Access Compliance Report

Public Rights-of-Way

Intersection ID: N/A	Main Street: HALKIRK_MANOR_LN	Cross Street: KIRKWYND_COMMONS_DR	Location: SW
ADA ID: F753ADE08A02	Ramp Type: PerpDiag	Initial Pass/Fail: Fail	Overall Compliance: No
Severity Score: 13.75			
Codes/Mitigation Info/Possible Solution		Field Measurements/Component Compliance

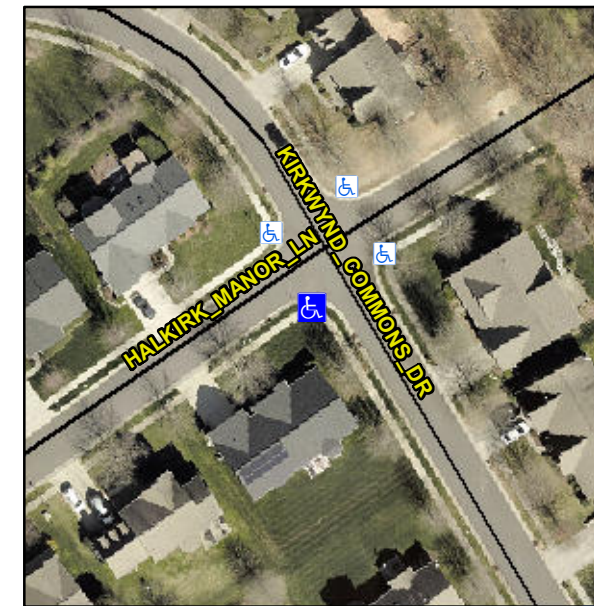
Not Found, R304.2.2, R304.5.3

Compliance	Description	Data	Compliance	Description	Data
N/A	Ramp Length (in)	46.0	No	Ramp Slope (%)	9.3
Yes	Ramp Width (in)	48.0	No	Ramp XSlope (%)	3.2
N/A	Flare Type LT	N/A	N/A	Flare Type RT	N/A
N/A	Flare Slope LT (%)	N/A	N/A	Flare Slope RT (%)	N/A
N/A	Flare Traversable LT?	N/A	N/A	Flare Traversable RT?	N/A
N/A	Landing Length (in)	N/A	N/A	DWS Provided?	N/A
N/A	Landing Width (in)	N/A	N/A	DWS Contrast?	N/A
N/A	Landing Slope (%)	N/A	N/A	DWS Length (in)	N/A
N/A	Landing X Slope (%)	N/A	N/A	DWS Full Width?	N/A
N/A	Landing Curb? (Y/N)	N/A	N/A	DWS Offset (in)	N/A
N/A	Shared Landing?	N/A			
N/A	Gutter Ponding?	N/A	N/A	Gutter Slope (%)	N/A
N/A	Gutter Lip Ht (in)	N/A	N/A	Gutter X Slope (%)	N/A
N/A	Painted X Walk1?	No	N/A	Painted X Walk2?	No
	X Walk 1 Direction	To NE		X Walk 2 Direction	To NW
N/A	X Walk 1 Width (in)	N/A	N/A	X Walk 2 Width (in)	N/A
	X Walk 1 Slope (%)	0.8		X Walk 2 Slope (%)	1.0
	X Walk 1 X Slope (%)	2.2		X Walk 2 X Slope (%)	2.1

Remove & Replace Curb Ramp With Two New Directional Ramps or Equivalent.
